DEPARTMENT OF PLANNING & INFRASTRUCTURE
Development Assessment

SUBJECT: NORTH PENRITH DEVELOPMENT SITE
S75W MODIFICATION TO CONCEPT PLAN (MP10_0075 MOD 2)

Figure 2B: Proposed 'Block Subdivision Plan'

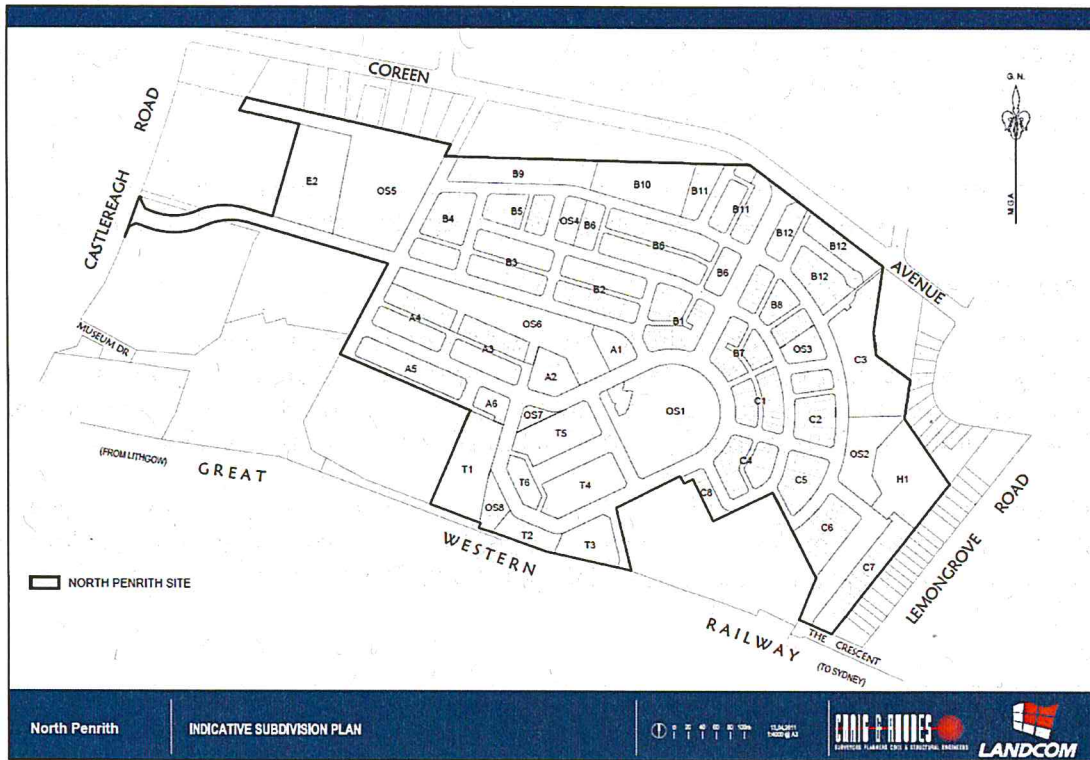
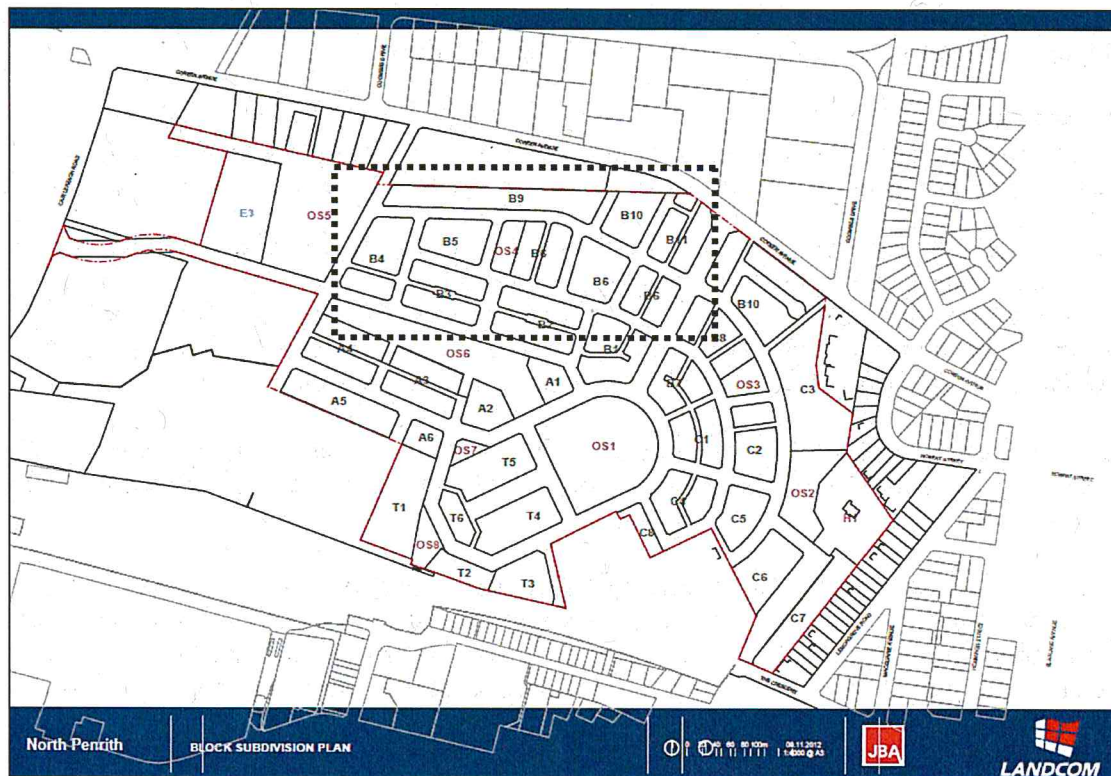
The proponent seeks to replace the approved subdivision plan in Schedule 1 of the Concept Plan approval (see figure 2A) with a new Block Subdivision Plan (see figure 2B).

The proposed modifications to stage 2D are illustrated in an overlay of the approved subdivision plan with the proposed block subdivision plan (see figure 2C below). Three new roads are proposed and two lanes removed. The new roads facilitate the re-orientation of many of the lots within stage 2D and provides the potential for the development of a higher proportion of east-west orientated dwellings.

The modification application states that this realignment of lots improves amenity due to the reduction in south facing lots, better permeability and a more direct dwelling exposure to roads.

The modified road pattern will impact the earthworks and provision of infrastructure and utilities however the overall pattern of development of the North Penrith site remains consistent with the approval. The dwelling yield and density is maintained and residential amenity improved. The department considers that the modification to the layout is acceptable.

Figure 3B: Proposed Staging Plan

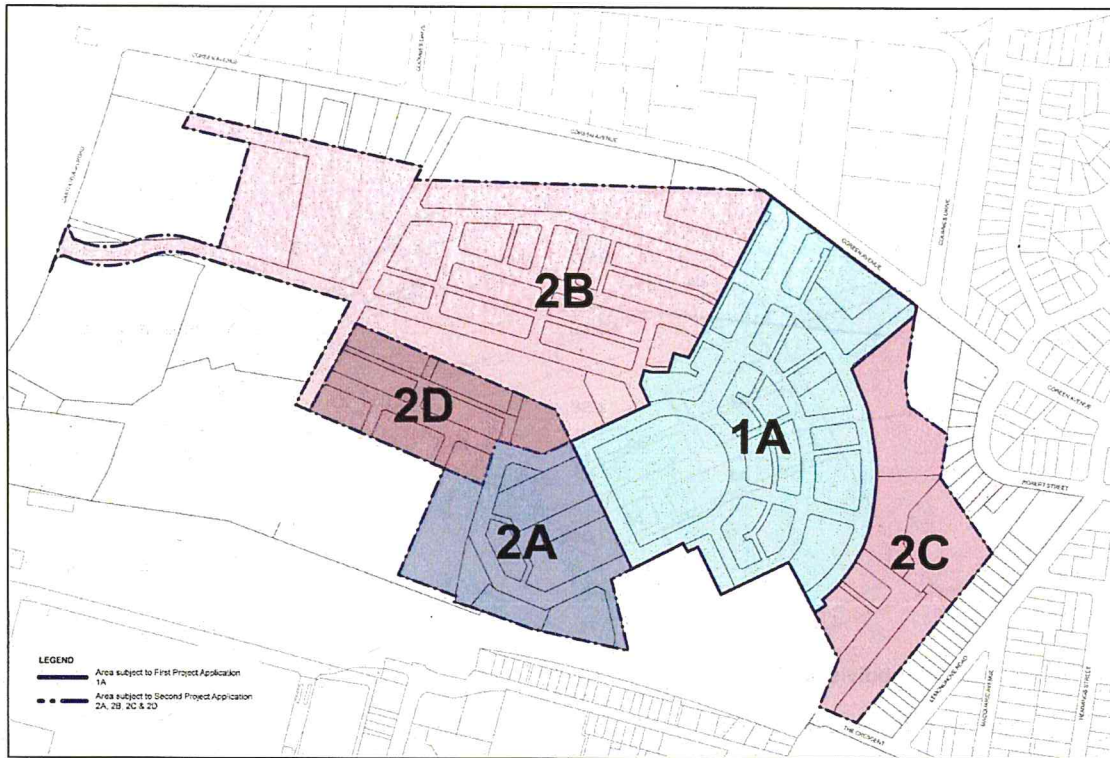
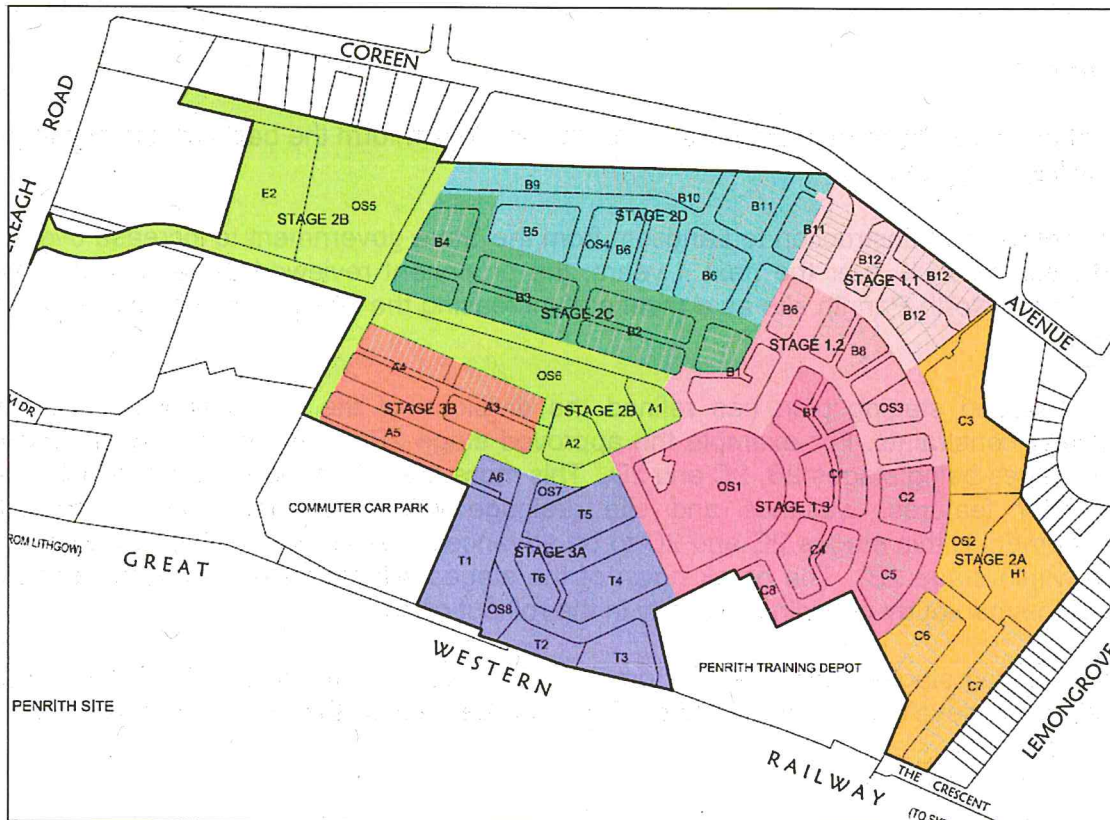
The proposed staging plan has refined the divisions of the site to isolate areas with particular constraints. For example the approved stage 2B is proposed to be divided into three stages being stages 2B, 2C and 2D. This more refined division of the site includes all the water features, wetlands and site drainage within the proposed 2B permitting development within stages 2C and 2D to be advanced independently of issues which may arise within stage 2B. The break down of the stages will expedite delivery of residential lots to the market by providing flexibility in the roll out of development.

The proposed staging plan does not provide any adverse outcomes and will assist in fast tracking the development of this site. The replacement of the approved staging plan is supported.

Figure 4B: Proposed Ancillary Dwellings Plan

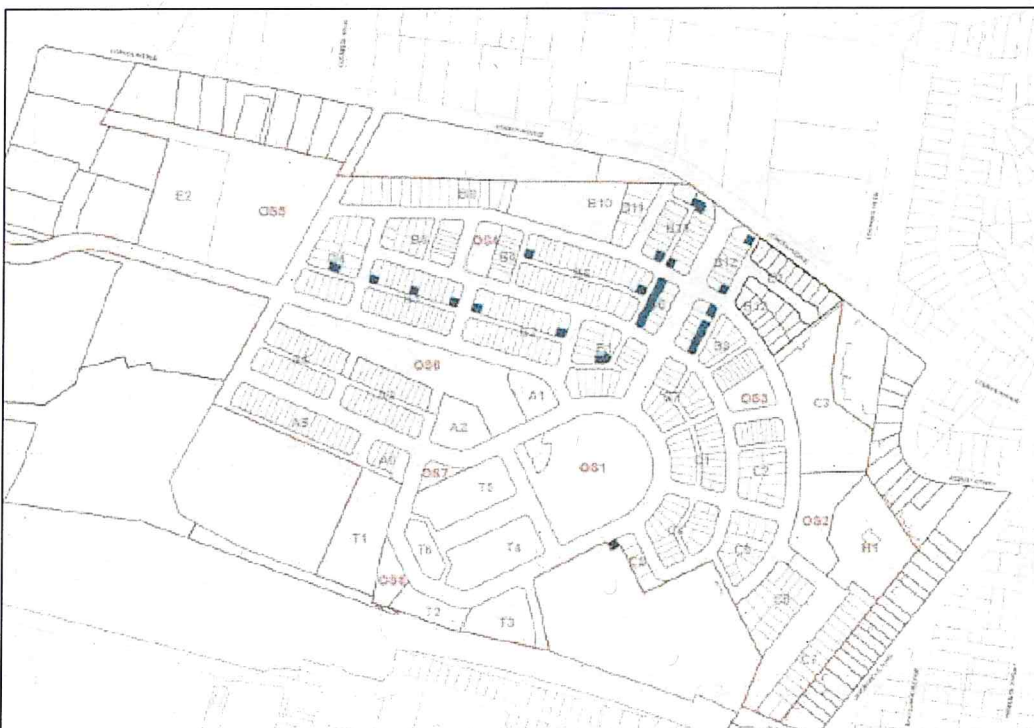
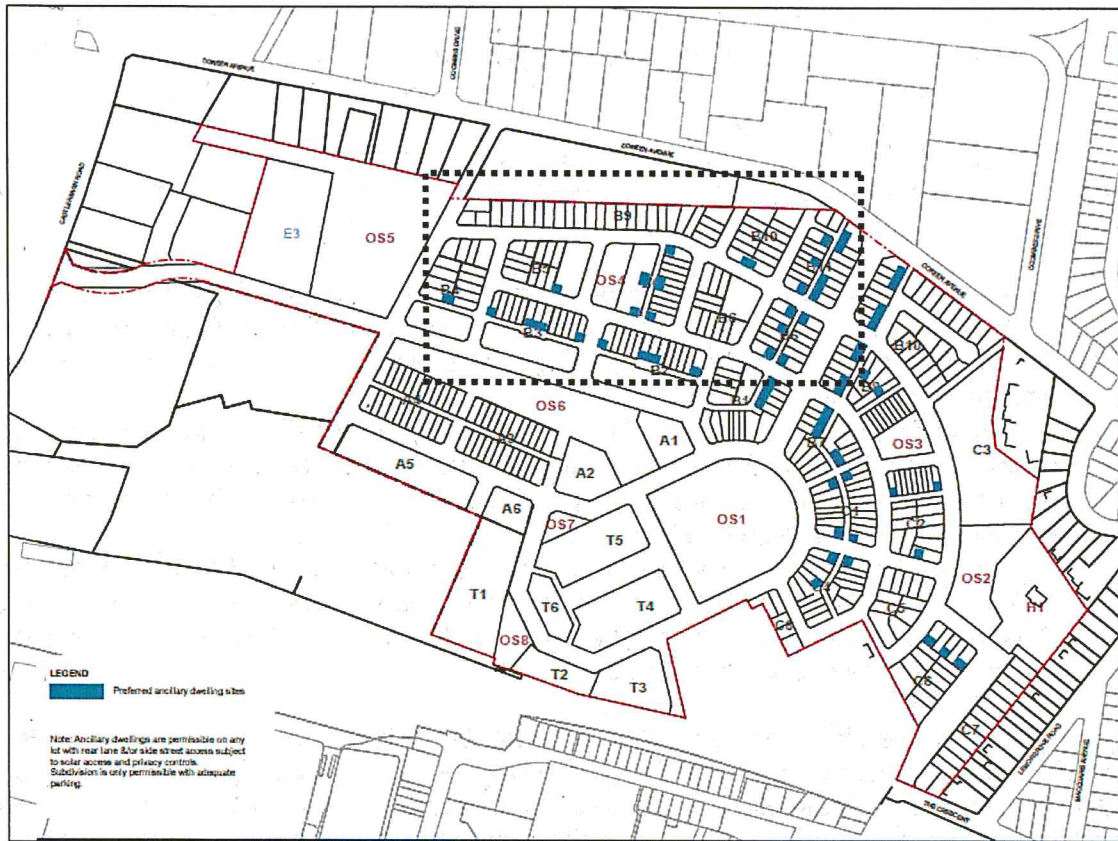
- Figure 4B indicates an amended distribution of ancillary dwellings not only in stage 2D but throughout the site compared to the approved plan at figure 4A. Ancillary dwellings include secondary dwellings and are to encourage a diversity of affordable housing;
- A comparison of figures 5A and 5B show that the proposed location and distribution of integrated housing has been modified due to the changes in the subdivision layout. Integrated housing will provide higher density housing within the provisions of the Design Guidelines.
- Figures 6B indicate the proposed apartment site to the north of stage 2D, as shown in figure 6A, has been removed due to a reduction of the lot sizes in this location. This will impact the number of apartment units however other forms of residential development have been increased.

A comparison of the plans indicates that although there have been some changes to the location of sites dedicated for particular dwelling types or densities, generally the diversity of dwellings types is maintained. Targets for dwelling yield across the entire site are provided in the Design Guidelines and the proposed amendments remain within the required targets. In consideration of the dwelling yield and density target remaining unchanged this proposal is acceptable.

It is recommended that the Design Guidelines be updated to incorporate the modified plans and that the terms of approval be modified to require the submission of the modified document in order to consolidate and clarify the Guidelines.
